RESOLUTION NO. 2016-26

Final Winter and Company Analysis and Testing of Proposed Development Code Report

DRAFT ZONING CODE

ANALYSIS AND TESTING

Facade Composition

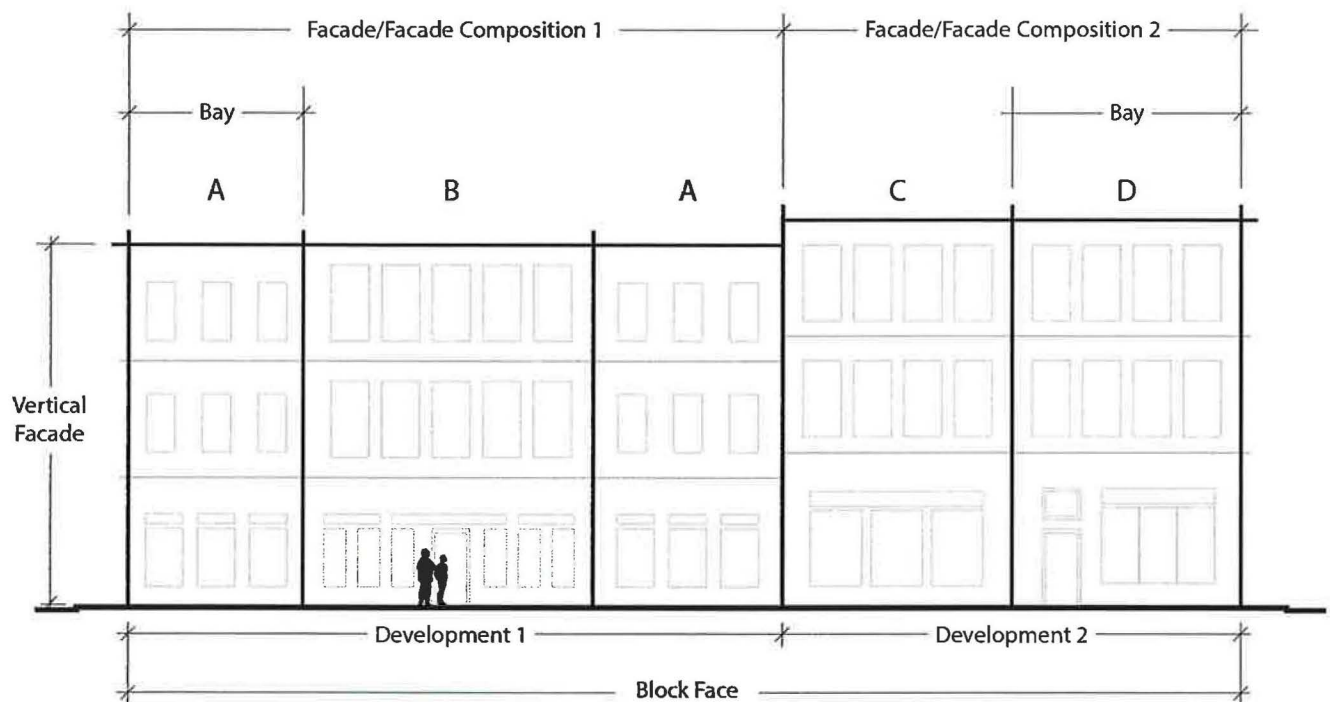
Facade Composition is discussed in section 29-4.2 d(2) of the draft code. The definition provides a clear differentiation between the groundstory and upper floor elements, but it is difficult to understand the concept of “Vertical Facade Bay Composition” and its relationship to “Bays” and the other requirements for achieving articulation in a facade are unclear.

Further clarification is needed to adequately describe the distinct elements of facade composition. These terms need clarification:

- Facade Composition - the wall of a single development?
- Vertical Facade - is this the same as facade composition?
- Complete and Discrete - as used to distinguish an individual bay?
- Bay - a “module” of a facade?
- Block Face - an entire wall of buildings along a street?
- Street Entry Door - as required for a bay or a facade composition?

HALF-BLOCK TEST:

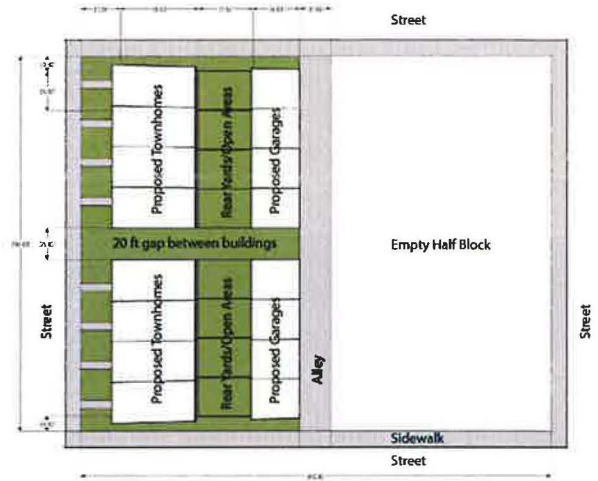
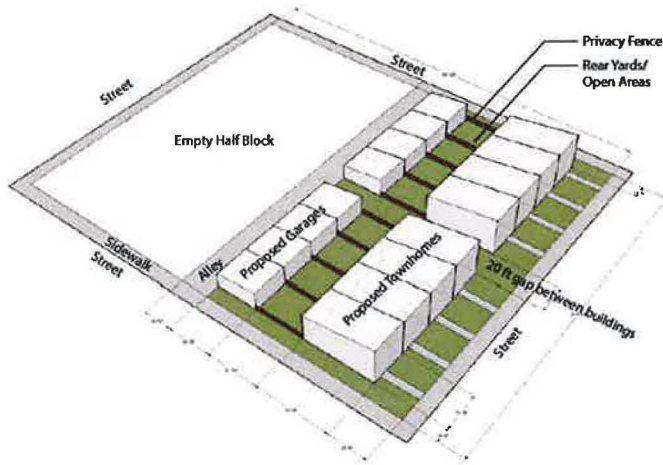
Areas of Question & Concern:

- **Parking setback area** - creates a setback condition that is not useful for development needs
- **Open area requirement** - limited to prime site area due to provisions and parking setback area
- **Street wall requirement** - no issues anticipated beyond clarity of fenestration and measurement
- **Curb cuts/Street access** - no issues anticipated
- **Maximum development area** - no issues anticipated
- **Facade Articulation & Fenestration** - no issues anticipated beyond clarity of code provision
- **Required Build-To Line** - no issues anticipated beyond the need to clarify the 75% code provision

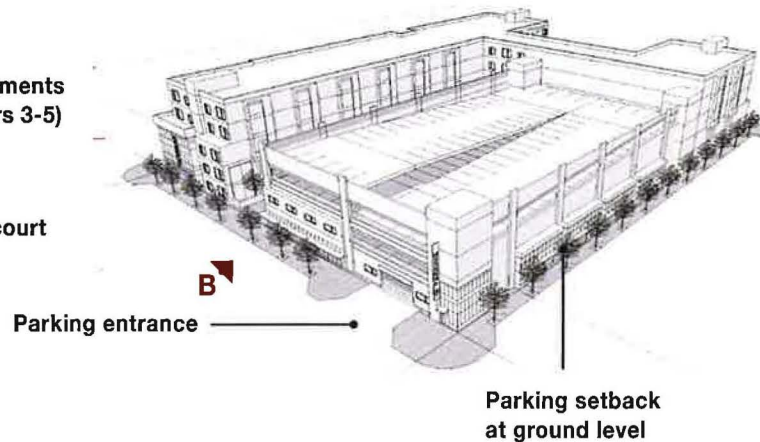
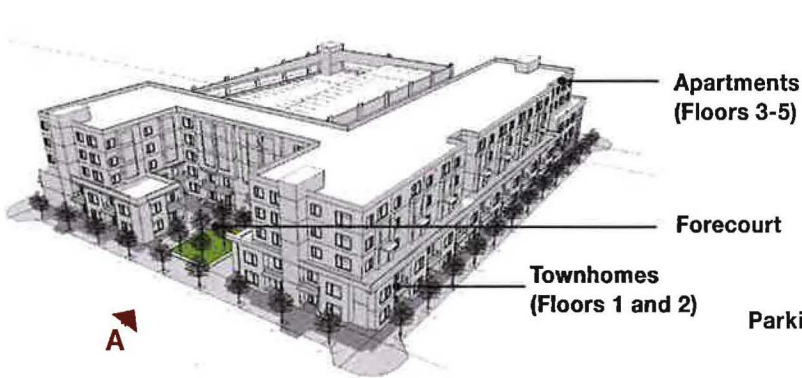
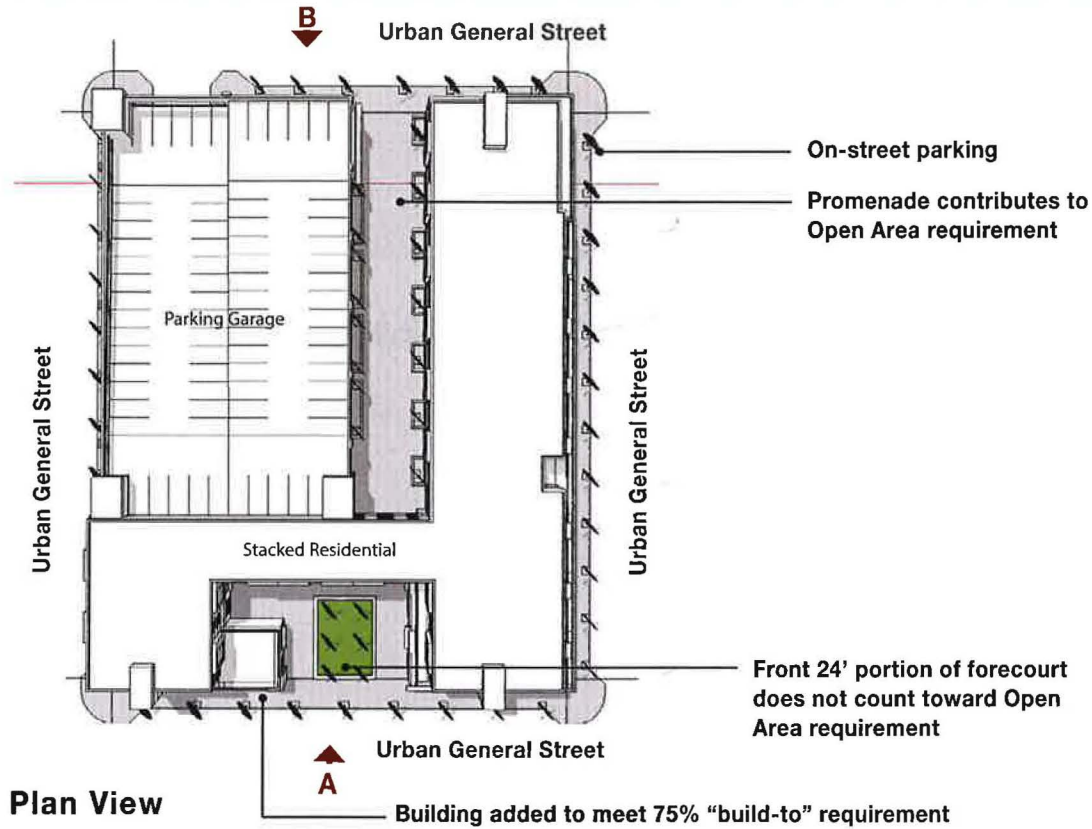
Standards Tested:

- **Parking setback area** - reduces the parking capacity by approximately 30 spaces on the ground floor
- **Open area requirement** - developed on ground floor, balconies, and roof to adhere to requirement
- **Street wall requirement** - feature not necessary in this project
- **Curb cuts/Street access** - no issues anticipated for this code provision
- **Maximum development area** - no issues anticipated for this code provision since parking garages do not count against the total
- **Facade articulation & Fenestration** - no issues anticipated beyond clarity of code provision
- **Required Build-To Line** - requires project to add “bump in “ to adhere to forecourt requirements

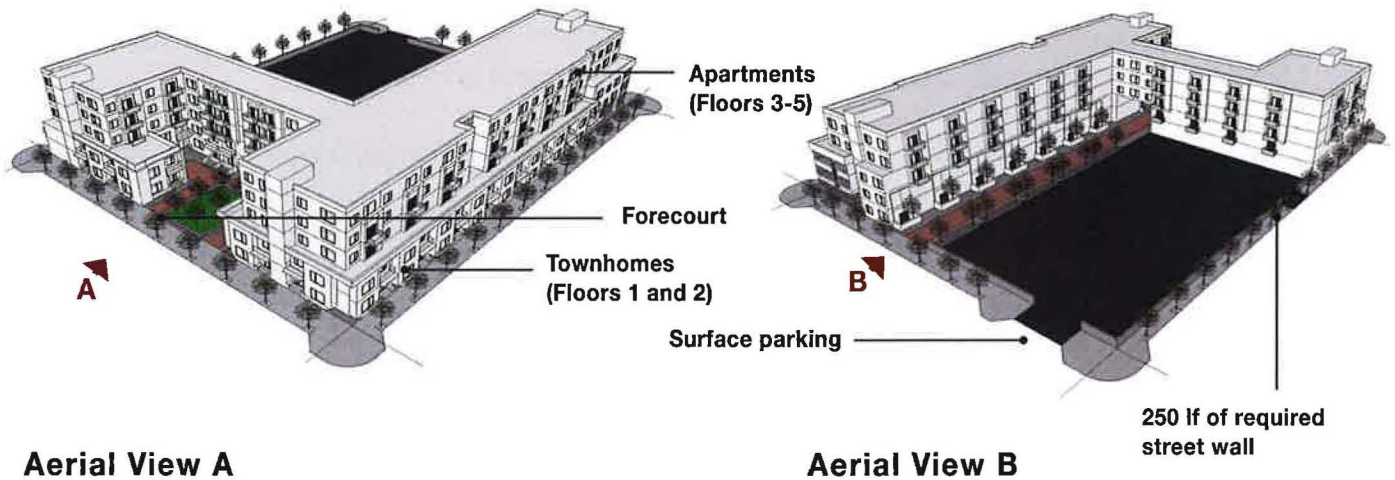
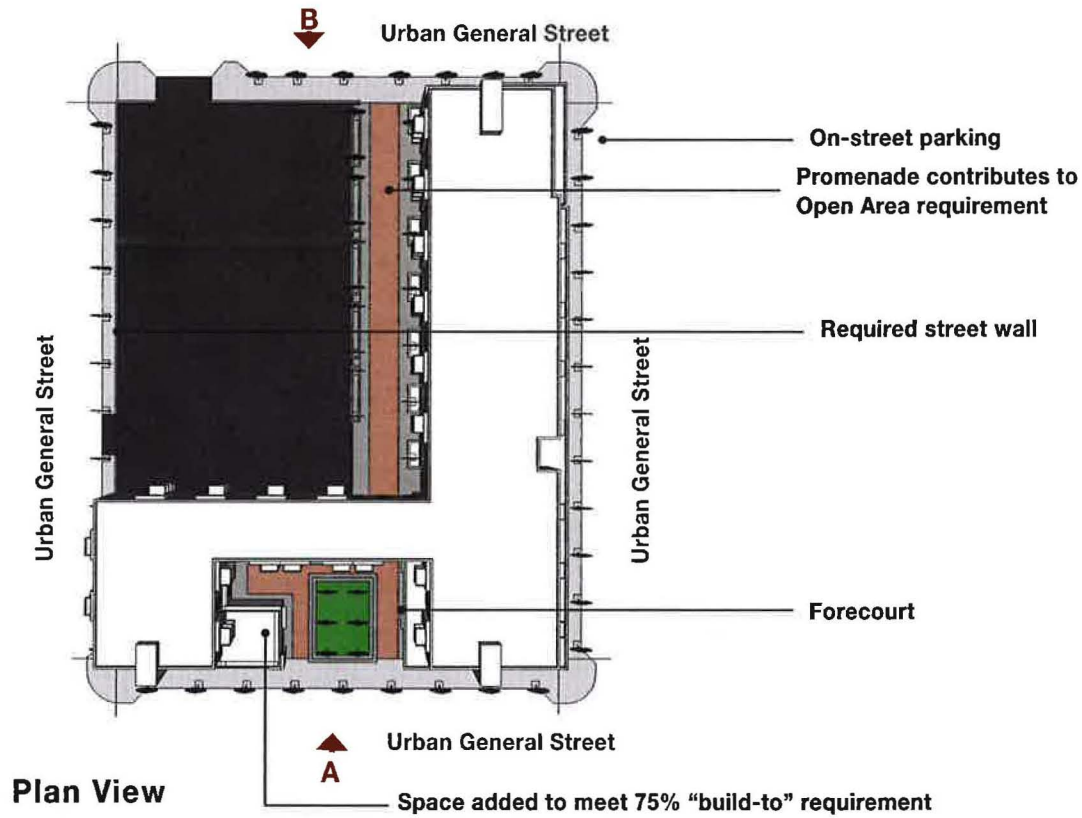
Standards Tested:

- **Parking setback area** - does not currently conform to this requirement, but would reduce the parking capacity by approximately 30 spaces
- **Open area requirement** - provided on ground floor, balconies, and roof to adhere to requirement
- **Street wall requirement** - application of this requirement is unclear in language of code
- **Curb cuts/Street access** - no issues anticipated for this code provision
- **Maximum development area** - no issues anticipated
- **Facade articulation & Fenestration** - no issues anticipated beyond clarity of code provision
- **Required Build-To Line** - requires project to add "bump in " to adhere to 75% "build-to" requirement

- This scenario is the most feasible of the Case Study #1 different scenarios
- Add ground story 'bump in" to adhere to forecourt requirements
- Project is non-conforming due to the lack of a parking setback area for the parking lot

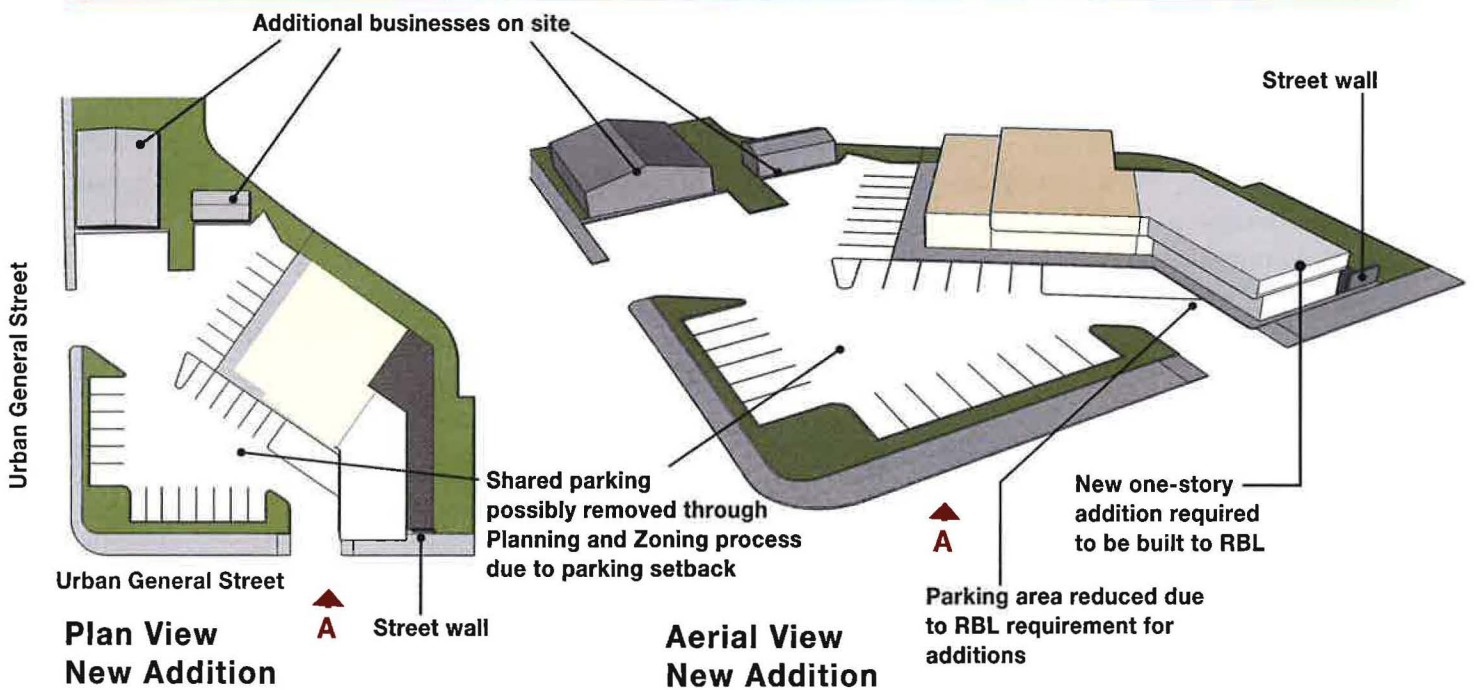
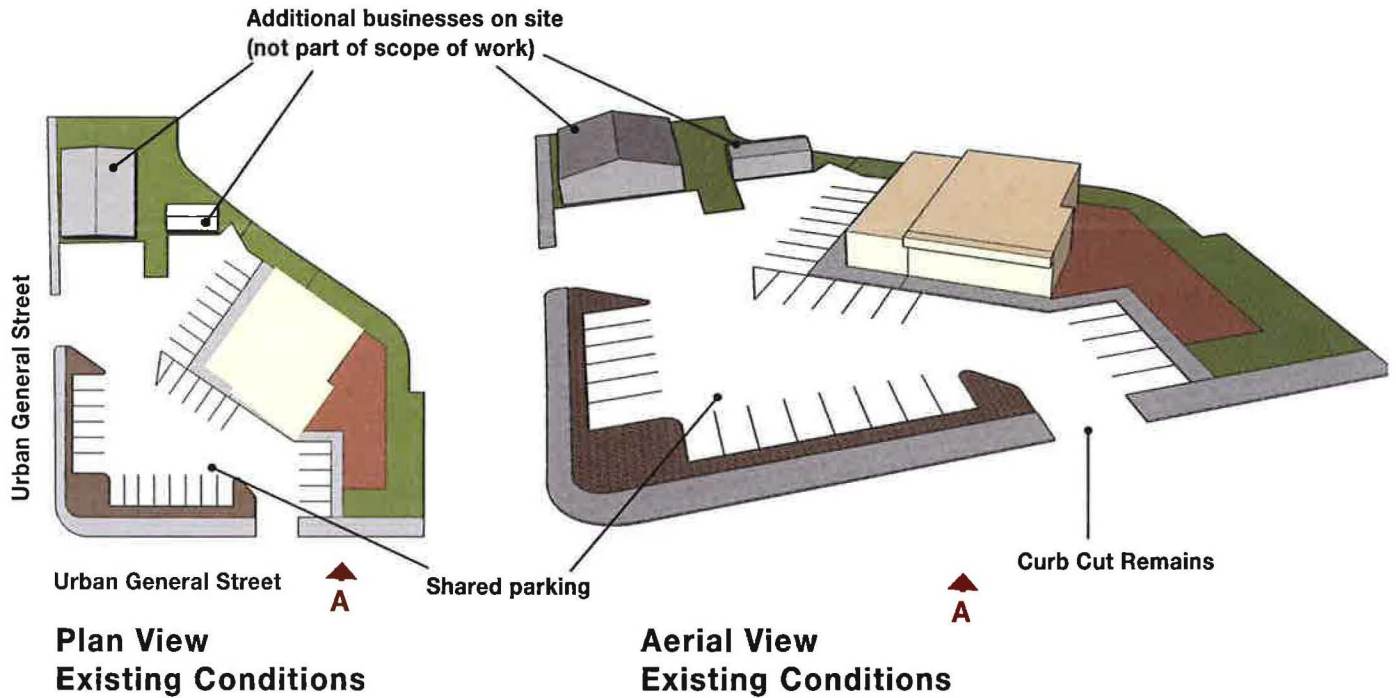
Standards Tested:

- **Parking setback area** - applicability for this provision is unclear due to site conformity requirements with addition. If site conformities are required, 16 spaces will be removed at corner interior.
- **Open area requirement** - no issues anticipated
- **Street wall requirement** - applicability for this provision is unclear due to site conformity requirements with addition. If site conformities are required, 200' of street wall would be added at RBL around corner.
- **Curb cuts/Street access** - no issues anticipated
- **Maximum development area** - no issues anticipated
- **Facade articulation & Fenestration** - no issues anticipated beyond clarity of code provision
- **Required Build-To Line** - requires addition to be built to sidewalk edge

- Project is not financially feasible
- The addition meets the Required Build-to Line (RBL), but does not meet owner's functional requirements
- Questions regarding whole site compliance vs. specific addition compliance still remain
- Parking setback requirements may eliminate over half of the on site parking (16 spaces)

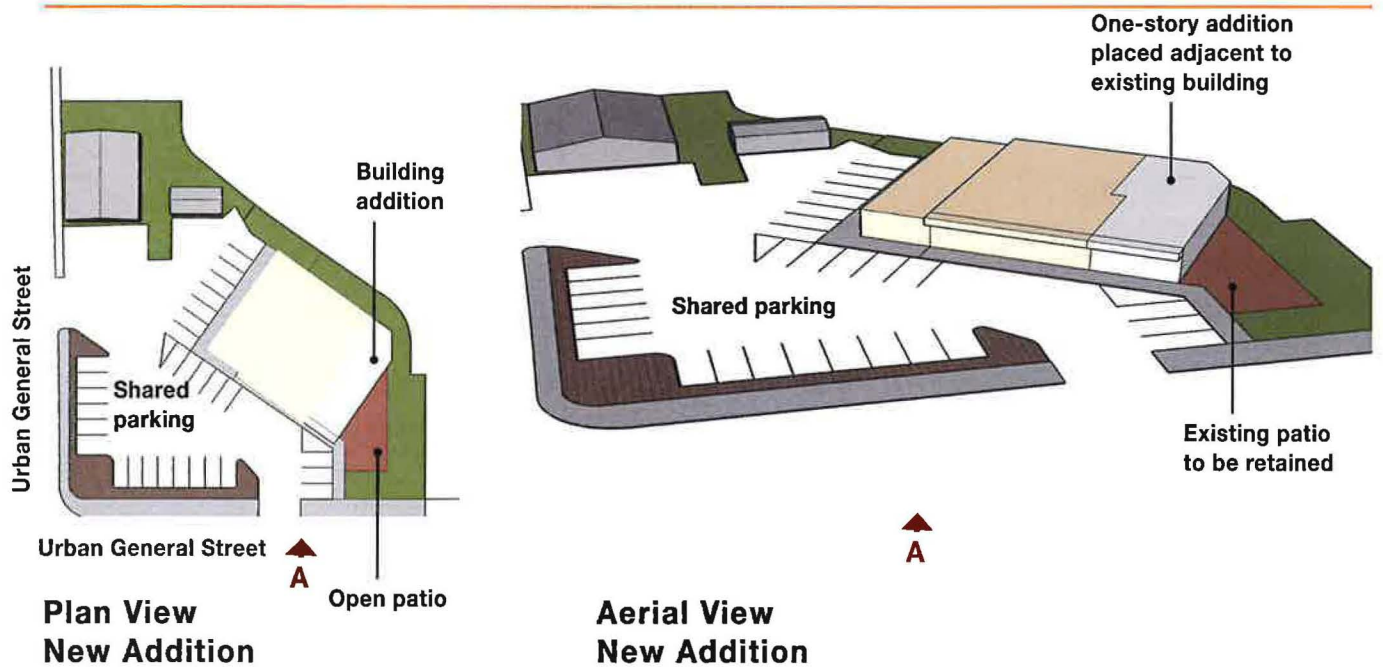
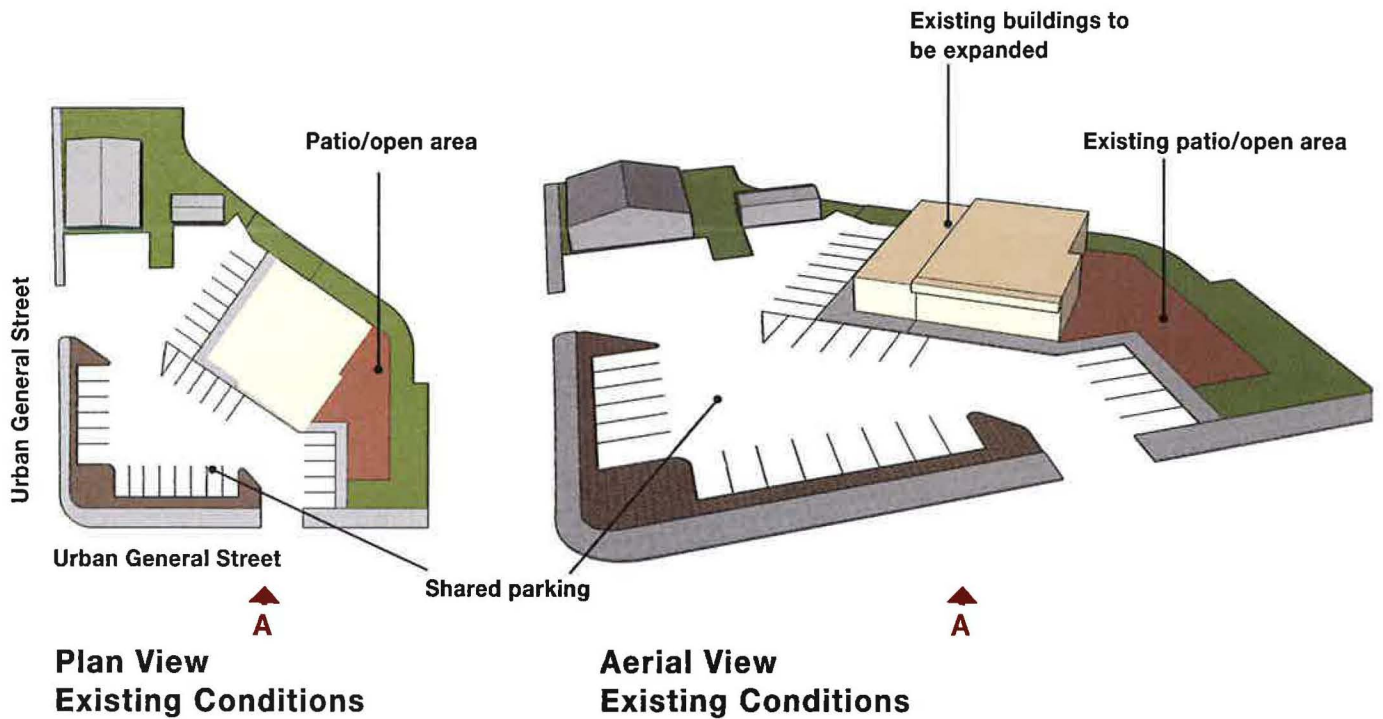
Standards Tested:

- **Parking setback area** - applicability for this provision is unclear due to site conformity requirements with addition. If site conformities are required, 16 spaces will be removed at corner interior.
- **Open area requirement** - no issues anticipated
- **Street wall requirement** - applicability for this provision is unclear due to site conformity requirements with addition. If site conformities are required, 230' of street wall would be added at RBL around corner.
- **Curb cuts/Street access** - no issues anticipated
- **Maximum development area** - no issues anticipated
- **Facade articulation & Fenestration** - no issues anticipated beyond clarity of code provision
- **Required Build-To Line** - this scenario does not have an addition that is built to the RBL

- Project is financially feasible when the building addition and necessary site work are considered in financial analysis and no other site work for open area or landscaping is included
- Preferred project addition is challenged by Required Build to Line (RBL)
- Questions regarding whole site compliance vs. specific addition compliance
- Parking setback requirements eliminate over half of the onsite parking (16 spaces)
- Existing patio area is retained and reused

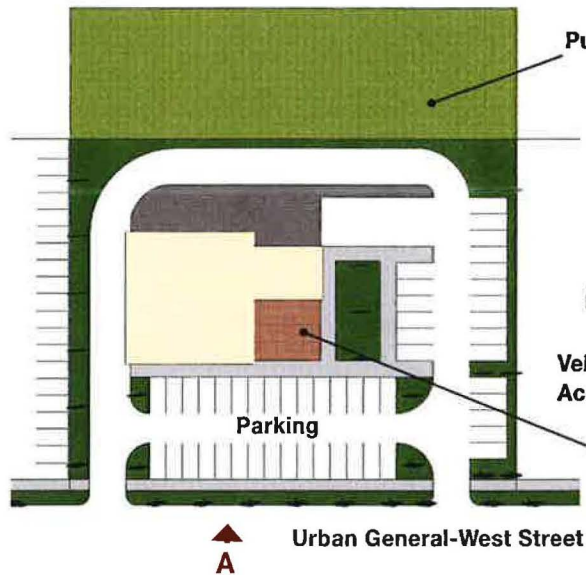
Standards Tested:

- **Parking setback area** - parking layout does not conform to this code provision
- **Open area requirement** - no issues anticipated
- **Street wall requirement** - no issues anticipated
- **Curb cuts/Street access** - no issues anticipated
- **Maximum development area** - no issues anticipated
- **Facade articulation & Fenestration** - no issues anticipated beyond clarity of code provision
- **Required Build-To Line** - new development does not conform to this code provision
